## **Appeal Observation**

### **OXIGEN FACILITY**

**ABP 318566 Offaly County Council Ref 22490**

#### **ON BEHALF OF RESIDENTS ASSOCIATION OF RHODE & CROGHAN**

Figure 6 Page 34 of Chapter 13 of the EIAR citing no traffic in a residential area

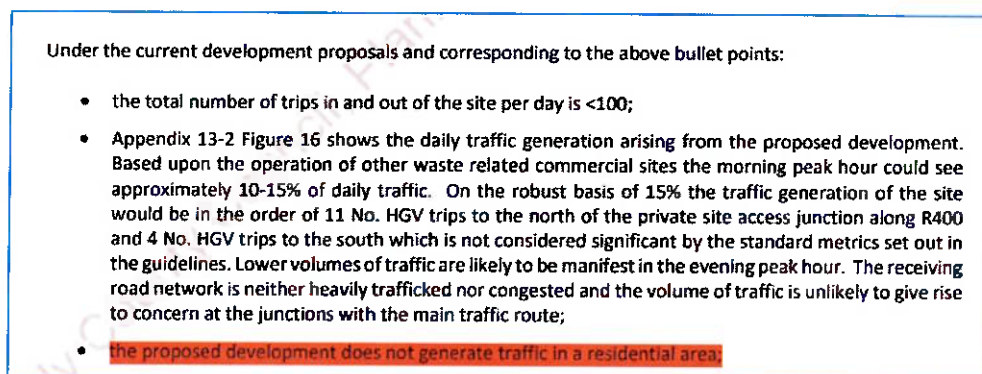
As will be shown later in the submission, 15K additional HGV trips will be generated by the facility annually all requiring routing through Rhode Village. The developer stating that no local roads will be used (as in Figure 5) is completely inaccurate. Later in Chapter 13 of the EIAR the reports states (shown in Figure 6) that the development does not generate traffic in a residential area. This is wholly inaccurate given the facility will directly generate 15K trips through the main residential area of Rhode village. All 15K HGVs will pass the local primary school.

Figure 7 Survey Completed by PMS dated Oct 2021 & Key Performance Parameters

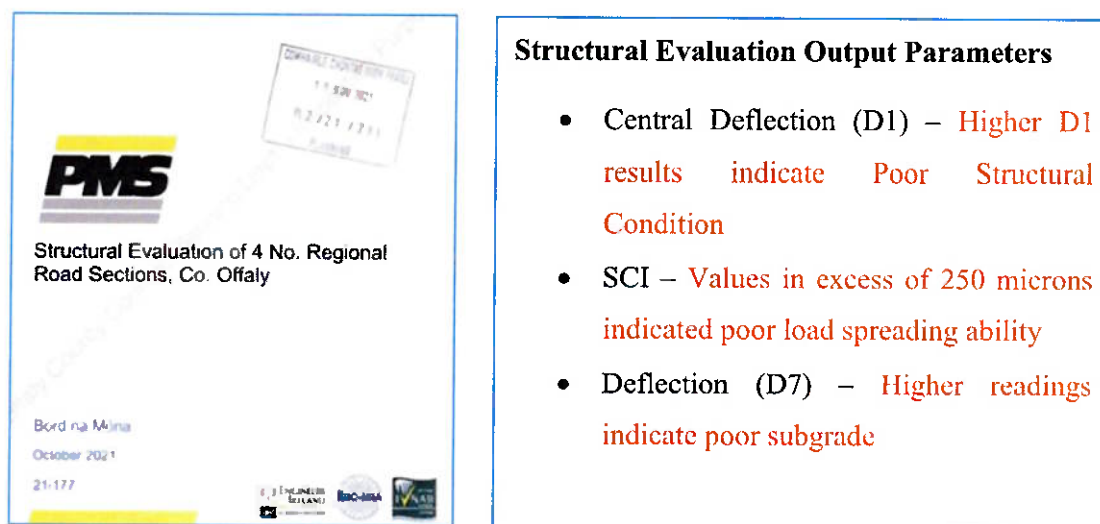
The right-hand section of Figure 7 above (taken from the report) notes that higher values of Central Deflection (D1) and Deflection (D7) indicate poor structural condition and poor subgrade respectively. Whilst Surface Curvature Index (SCI) values in excess of 250 microns indicate poor load spreading ability.

Figure 9 R400 Performance - Good, Poor and Bad Classification

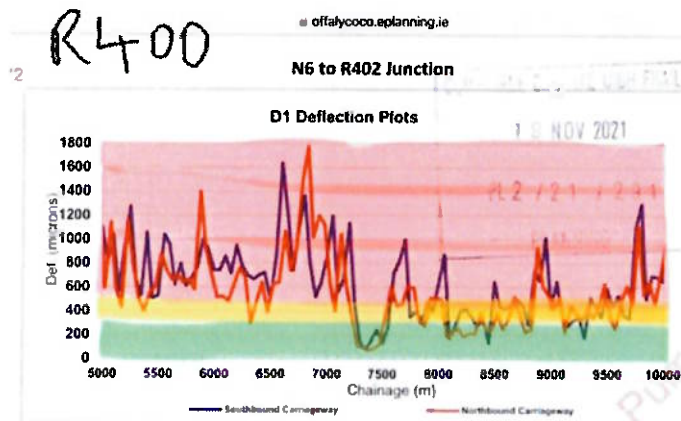
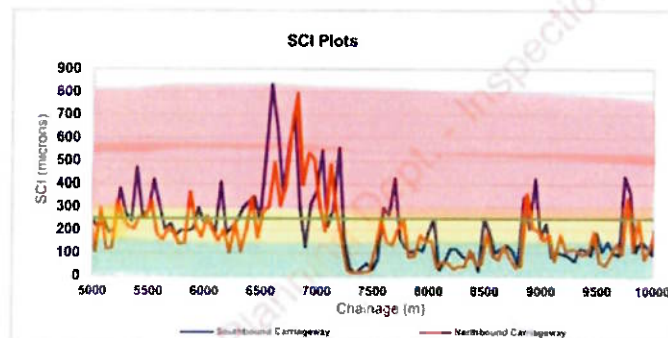
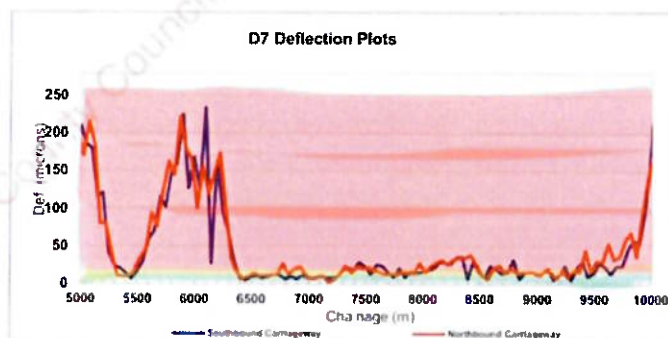
The survey included 4 road sections totalling approximately 36 kms. The 4 road sections are divided into 32 chainage sub sections. The R400 accounts for 15Kms of the total routes surveyed. The performance of the R400 as graphed in Figure 9 shows **poor structural condition, poor load spreading ability and poor subgrade** throughout and further notes the initial sections from the N6 (from Rochfortbridge) through Rhode village as being in particularly bad condition.

**Figure 11 Assumption of Rigorous Assessment by OCC**

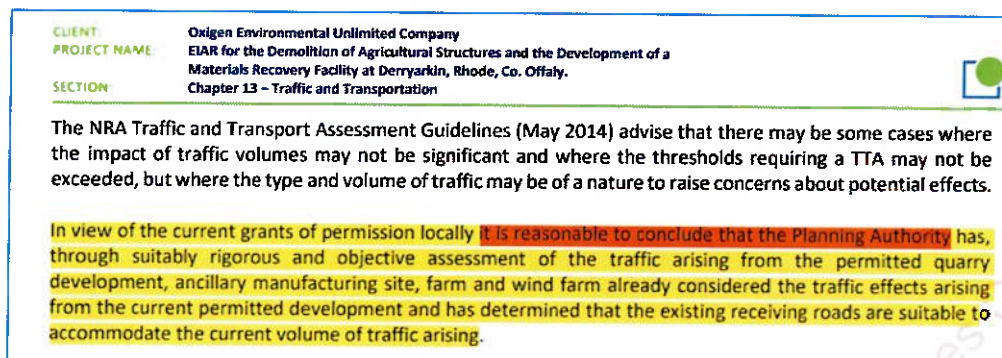
The excerpt from Section 13<sup>5</sup> of the EIAR Transport chapter as shown in Figure 11 quotes “*it is reasonable to conclude that the planning authority has through suitable rigorous and objective assessment*” ...concluded ...“*that the existing receiving roads are suitable to accommodate the current volume of traffic arising*”. Given the road condition outlined in the PMS report and the capacity issues evident on the R400 already, such an assumption cannot be taken to be likely or robust.

Figure 23 Theoretical Proposed Route (12 Versus 20kms)

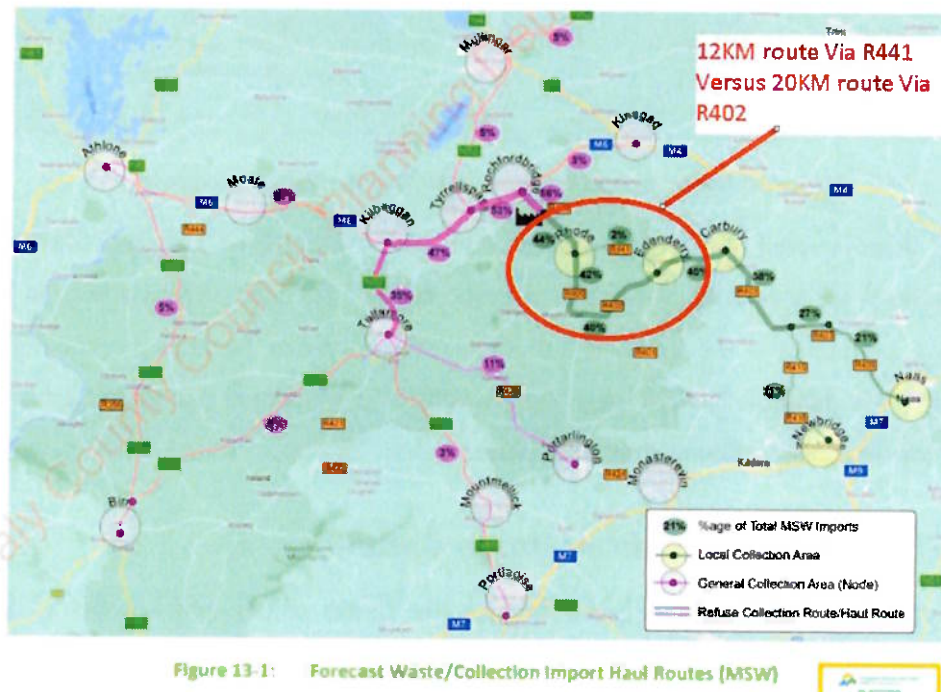
The proposed route for imports via the R400 as shown in Figure 23. The shortest distance from Edenderry to Rhode (R441) is 12Kms whereas the proposed designated route is via the R402 which is 20kms. No commercially operated company will choose to travel 8kms extra per trip. Whilst on paper this may be a plan, in practice there is no incentive or policing that will ensure this route will be followed. This would equate to Oxigens HGV's travelling an extra 125,472 kms (15684 trips x 8km additional). The reputation of the developer as discussed herein, gives zero confidence that the designated route would be followed.

**Figure 25 Examples of outdated Documentation**

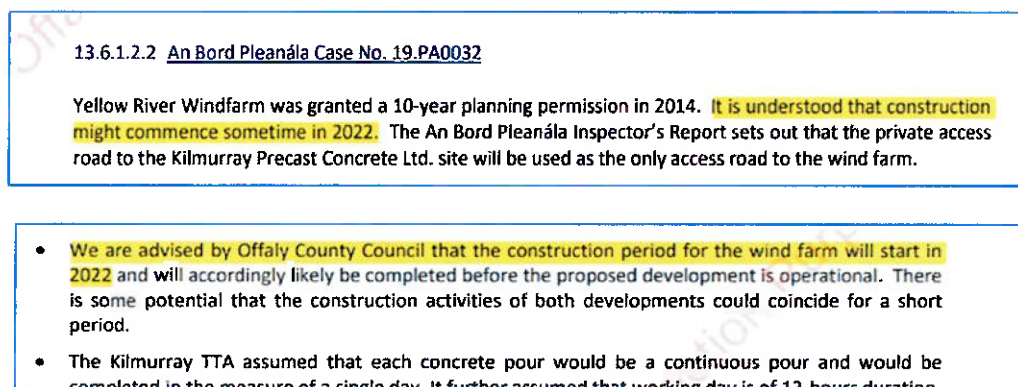
The developer simply resubmitted the same documentation without updating the status of the information contained within. The approach undermines the quality and standing of the overall submission. The significance of the development for the local residents should necessitate an up-to-date application which gives comfort to decision makers that it has been reviewed and updated in full. References to 2022 being in the future as shown in Figure 25 demonstrate the documentation was not reviewed.

Figure 26 Sept 2022 Reporting of Fire in Dundalk at Oxygen Facility / Youtube Image

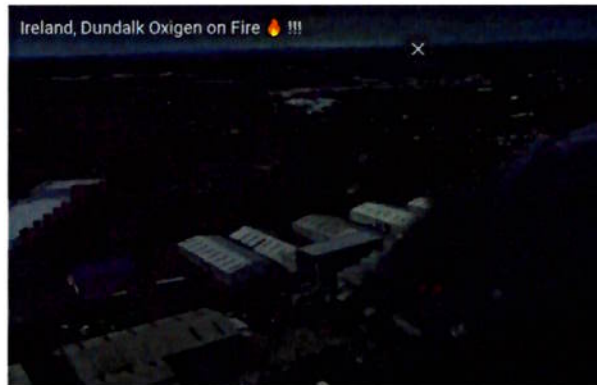
The applicant proposing the development (Oxygen) has an extremely poor record with serious fires at their facilities in Ballymount in 2014 and in 2022 in Dundalk Co. Louth<sup>11</sup>. The former incident was investigated by the EPA who quoted in their report that *"there was an extensive smoke plume from the fire and the smell was reported widely throughout Dublin and received extensive media coverage from Figure 26"*. The fire burned for 4 days<sup>12</sup> with the air quality and consequently the public health being put in jeopardy. It is evident that the applicant did not learn from the initial incident given the serious recent reoccurrence. Offaly county council should learn from both incidents and avoid putting the welfare of local residents in Rhode, Croghan and in adjacent Rochfortbridge, Co. Westmeath in danger.

Figure 31 Approved Development of Gas Power Station at Derrygreenagh

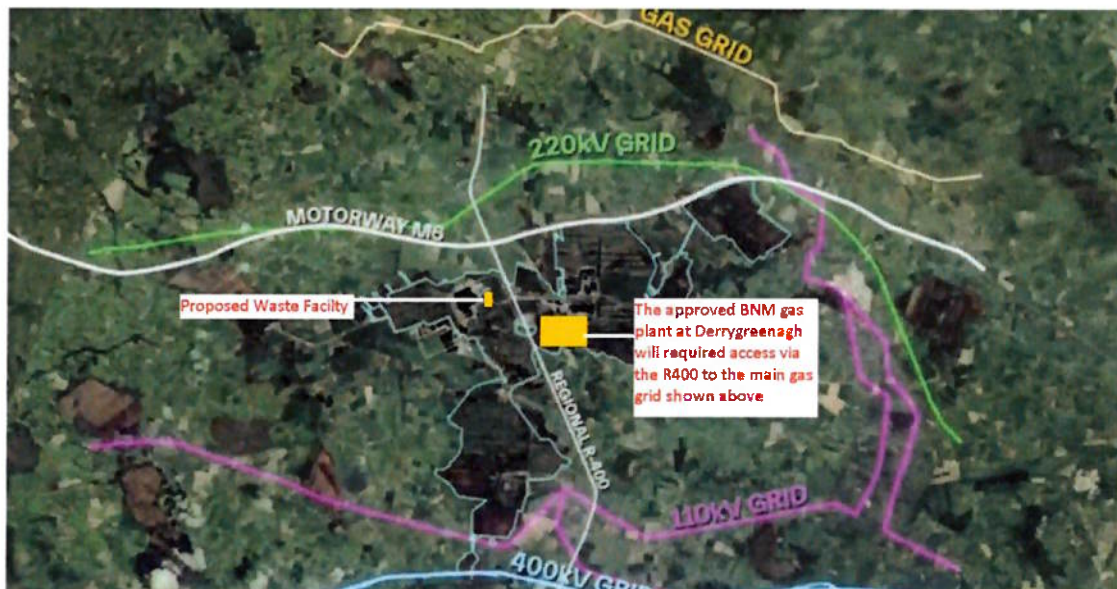
It should be noted that the approved gas plant for Bord Na Mona at Derrygreenagh will require connection to the gas mains depicted on Figure 31. The R400 presumably will be required to facilitate this connection. Given the quality of the road outlined herein, the challenges of bog construction for a gas mains need to be considered by all granting authorities. The significance of increasing traffic on this route will likely be a restricting design constraint.
